Table 1 Response to EPD's Request for Supplementary Information (Ref: EPD's letter dated 9th March 2011)

ANNEX A

Update to EIA Report Section 4.6.4 Trees within the Project Site (Figures 1 and 3)

Figure 27. Before damage by Typhoon Fengshen, T4 (*Celtis sinensis*) had restricted crown development only on the south side, and extensive dead and dying branches. Note the limited exposed soil at the trunk base (photos supplied by the Trust).

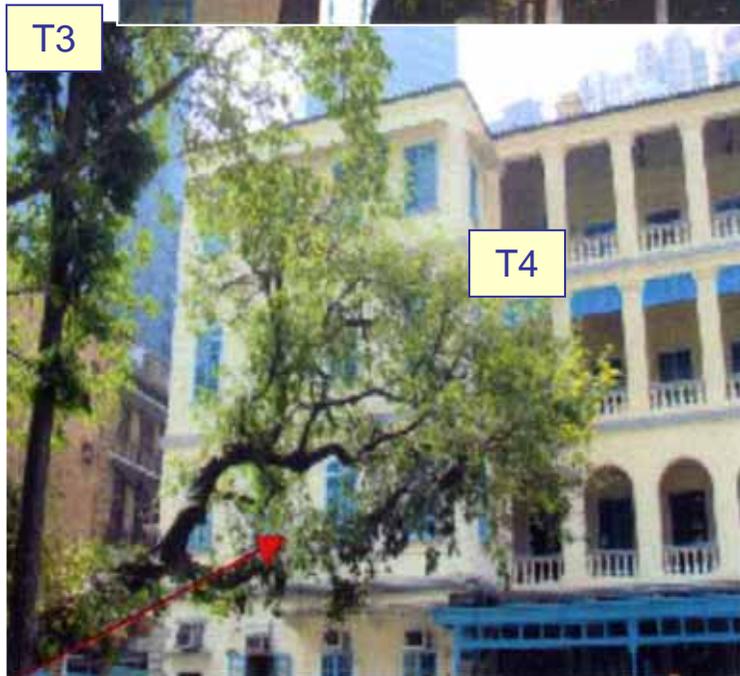
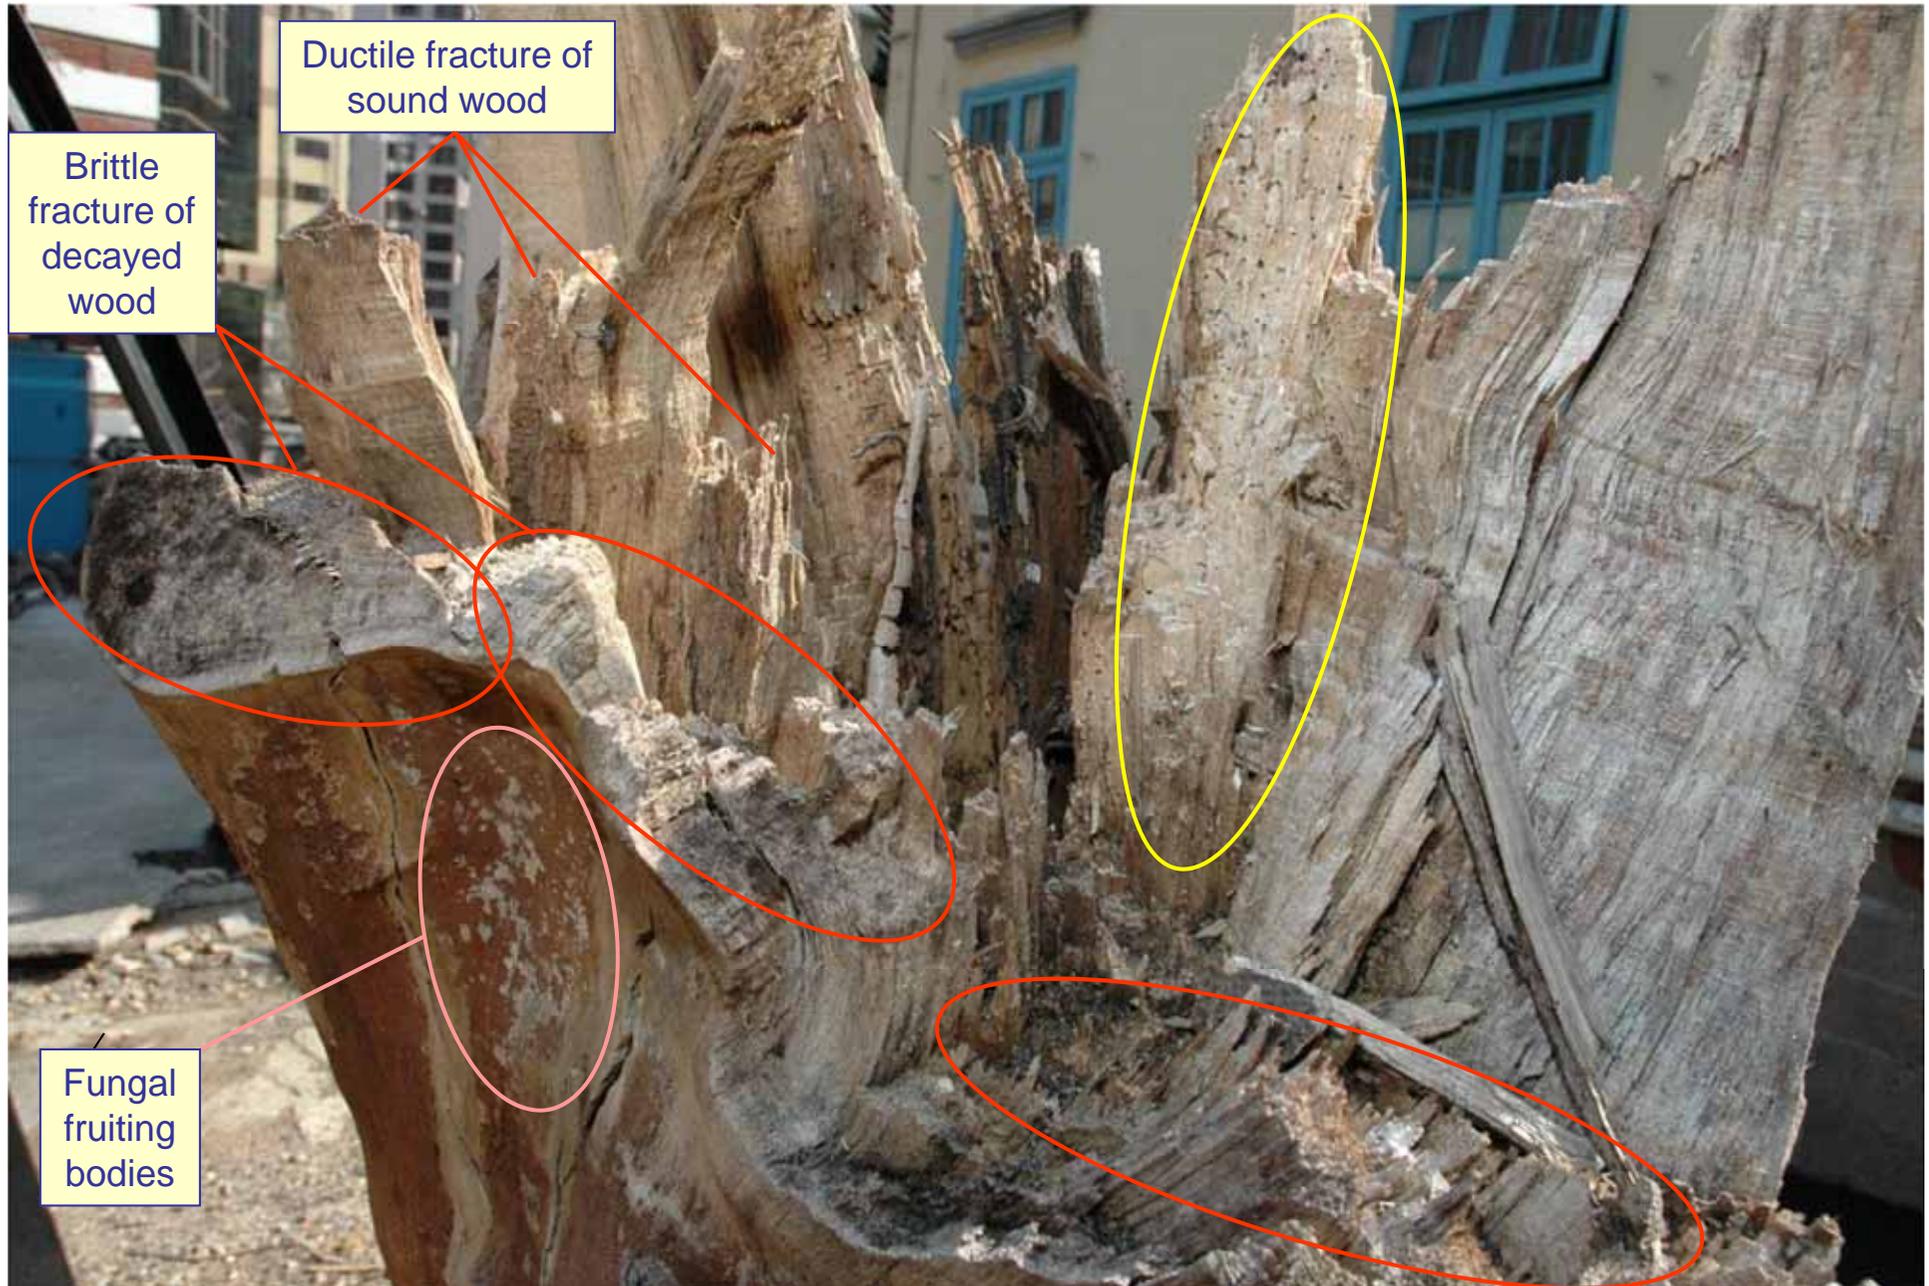
T4 – *Celtis sinensis* (Figures 27 to 32)

T4 was snapped at about 1.8 m from the ground by Typhoon Fengshen on 25 June 2008, leaving a stump with jagged fractured wood at its top. It is a native broadleaf deciduous tree that commonly dwells in mature local woodlands and can reach 16 m height. An inspection in February 2009 concluded that prior to its snapping, T4 was already a hazardous tree that could have broken or toppled suddenly without any warning. T4 is now considered to be dead.

T4 is now considered to be dead and the stump of T4 should be removed with the major structural roots below the trunk base being extracted by a stump grinder. Despite no compensatory planting being required, it is suggested that the entire strip of land that previously accommodated T1 to T4 should be revamped to provide a planting site with improved soil conditions for future tree growth and six trees be planted here, as detailed in CM6 of Table 4.5.

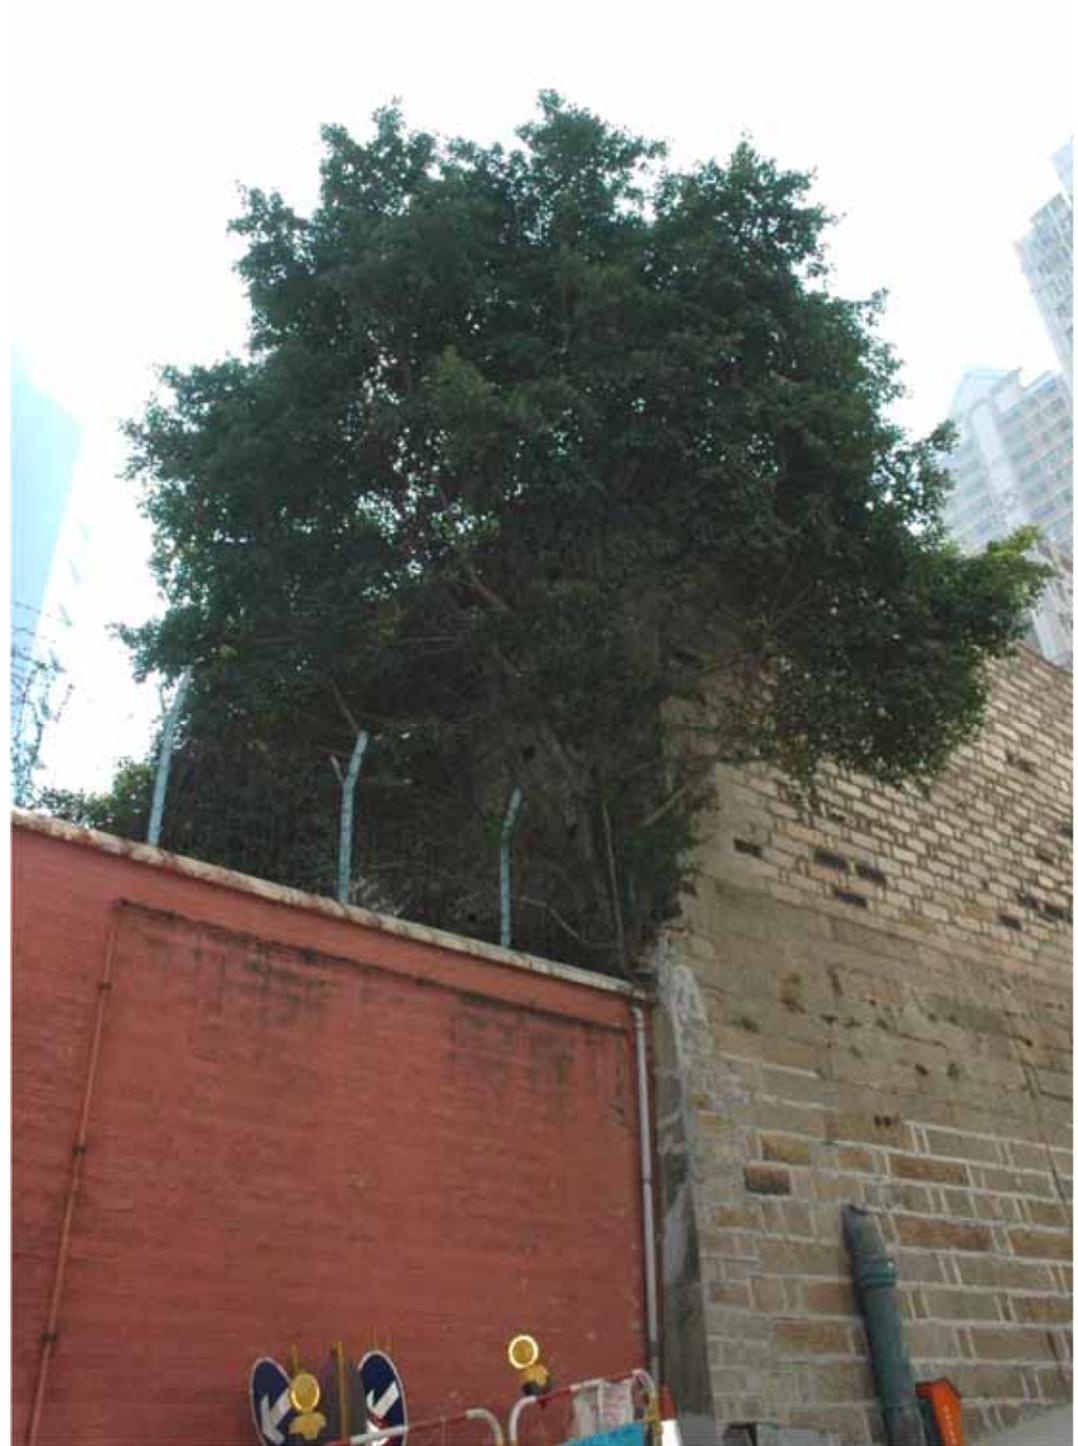
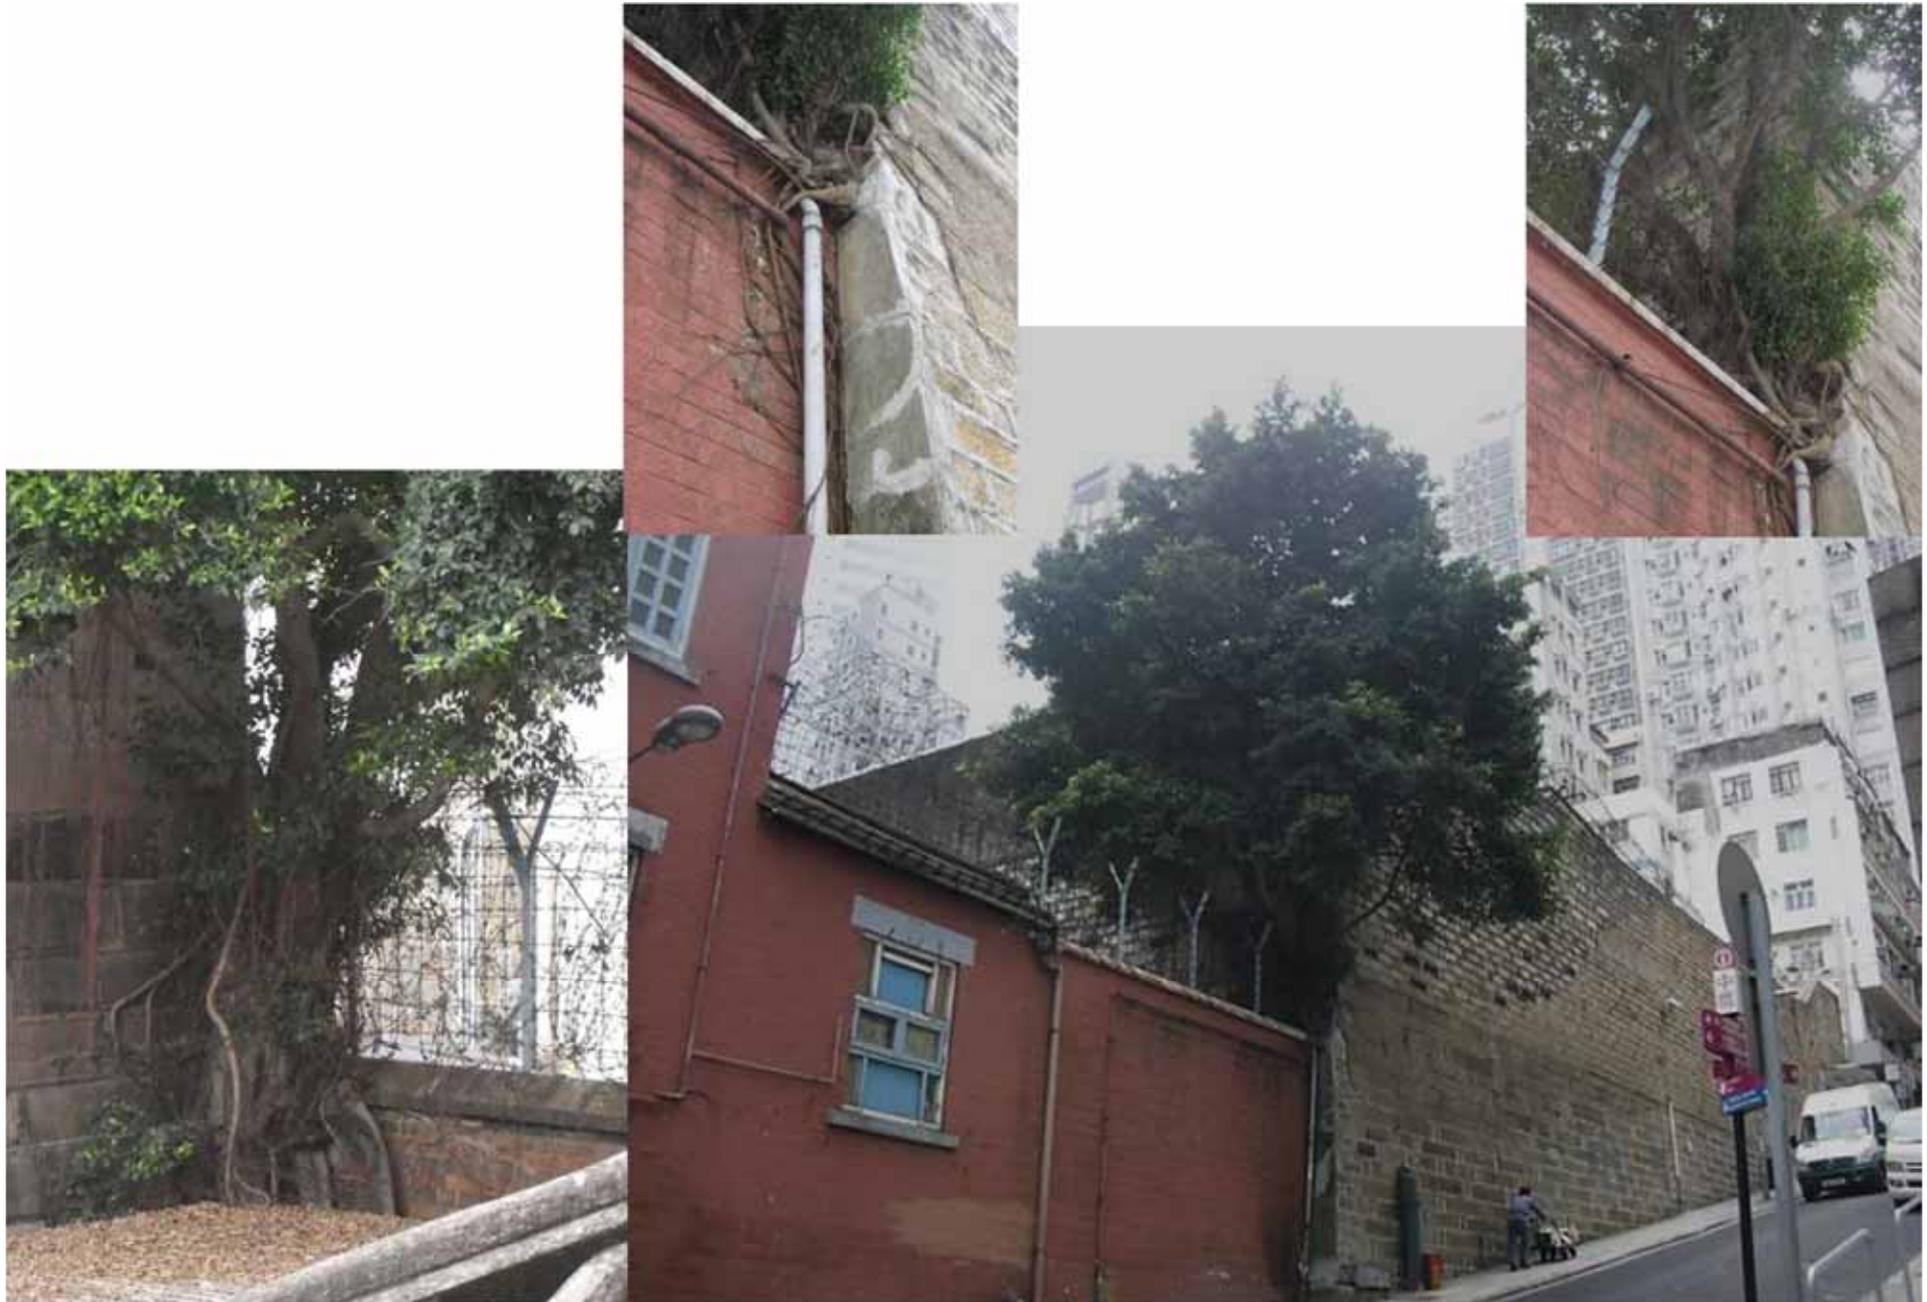
Supplementary Information Required	Project Proponent's Response
<p><u>Tree Preservation</u></p> <p>1. Supplementary and latest information on tree assessment, tree preservation, tree felling, the existing conditions of the trees which are numbered T10, T1, T2, T3 and T4 in the EIA report and the compliance with the "Environment, Transport, and Works Bureau Technical Circular (Works) No. 3/2006 Tree Preservation" (which is available at internet website: http://www.devb.gov.hk/filemanager/technicalcirculars/en/upload/16/1/c-2006-03-0-1.pdf).</p>	<p>Preservation and management of the existing trees have been carefully considered in the landscape impact assessment of the EIA. A team of experts including Prof CY Jim, Chair Professor of Geography, The University of Hong Kong, has conducted careful examination to assess their conditions and made appropriate recommendations. The same team has conducted a review of the latest conditions of trees T1, T2, T3, T4 and T10. The recommendation in the EIA Report remains valid, ie T1 to T4 (3 dead trees and 1 in poor health condition) are recommended for removal and they are not subsumed under the tree felling application while T10 is also recommended for removal as it is in conflict with the new access road after considering (i) the need for a new access road at that location and (ii) the feasibility of transplanting the tree.</p> <p><u>Need for a new access road on Old Bailey Street</u></p> <ul style="list-style-type: none"> • Careful site analysis found that it is not possible to install a new entrance along either Arbuthnot Road or Chancery Lane. • The vehicular opening on Old Bailey Street and a service yard are necessary for the transport and future maintenance of new electricity transformer equipment as well as the loading and unloading needs. The electrical transformer will be housed inside the Ablutions Block, the best place to "hide" them as they cannot be put in a basement. The transformer equipment is essential to the revitalization of the site with or without new construction. • The service yard needs to be 9 m wide in order for essential service vehicles to turn around as Transport Department will not allow reversing out onto Old Bailey Street.

T10 – *Ficus microcarpa* (Figures 33 to 38)

T10 is a wall tree that established spontaneously without human assistance. It has multiple trunks to support a full tree crown with dense branches and foliage, in a normal posture similar to a ground-growing Banyan. The tree measures approximately 6 m tall with a 6 m crown span. It is considered to be about 20 years old and in good health.

T10 does not take up ground space having established on an apparently vertical habitat. It is located at the boundary of the Police and the Prison sites, at the junction between the stone retaining wall and the adjacent, perpendicular, free-standing, brick wall that marks the Old Bailey Street perimeter. The stone retaining wall has soil kept behind its façade (“retained soil”), and the roots of T10 have penetrated the joints between the masonry blocks to spread in the retained soil so as to acquire a firm anchorage and capture water and nutrients. The free standing brick wall does not hold soil. The surface roots of T10 have

The feasibility of installing the new access road whilst preserving T10 has been considered. The proposed gap for the access road is the minimum required for emergency vehicle access and the entire width of the gap from the ground upwards has to remain clear of obstacles. The main branches of T10 begin to grow outwards towards the proposed gap just above the brick wall at about 3 m from the level of Old Bailey Street and its overhanging branches would limit the head room of the proposed road, thus disqualifying it as an emergency access. In situ preservation of T10 would also have to involve protection of both walls and the companion soil in a holistic package. Any damage to the two walls and their companion soil would injure or cut the lateral and feeding roots reducing the water and nutrient supply to the wall tree and seriously compromising its stability. Since creating the access road would damage the roots on the brick wall and in the ground soil T10 would be weakened and destabilized. It is therefore concluded that the co-existence of the new road and T10 is not possible.

Since T10 cannot be retained, the option of transplanting it has also been considered. To move T10, two requirements would need to be fulfilled: (1) taking two wall segments of sufficient dimension to keep most of the lateral roots; and (2) taking two root balls respectively for the retained soil and the ground soil, each of which must contain a sufficient volume of companion soil together with their constituent feeder roots. During the transport stage, the four entities plus the above-ground part of the tree ("the shoot") would need to be moved en masse as one unit without any relative movement to each other in the course of lifting and conveyance, to avoid their breakage or disintegration. These stringent requirements are technically very difficult to accomplish and are unlikely to be satisfied. In addition, any attempt to move the four entities would demand heavy lifting machines which require a wide road access, a flat and strong platform, and a large amount of manoeuvring space. These indispensable conditions are unlikely to be satisfied given the cramped condition of the tree site and the adjacent steeply-sloping and narrow Old Bailey Street. In view of technical and site difficulties, it is understood that no wall tree has ever been transplanted successfully in Hong Kong or other cities. The expensive and complicated operation in this instance is unlikely to succeed and given T10 does not have any outstanding dimensions or qualities it is considered unreasonable to attempt such an elaborate, expensive and unproven transplanting operation. It can therefore be concluded that transplanting the wall tree is not a viable option.

The size, tree form, performance, and landscape and amenity value of T10, in comparison with the large and robust wall trees in other parts of the city, are relatively low. Due to site and technical constraints, in situ preservation and transplanting cannot be recommended. Overall, considering alternative locations of the new access road would require the demolition of high quality and culturally valuable heritage structures, the felling of T10, a relatively average wall tree, is deemed an acceptable option.
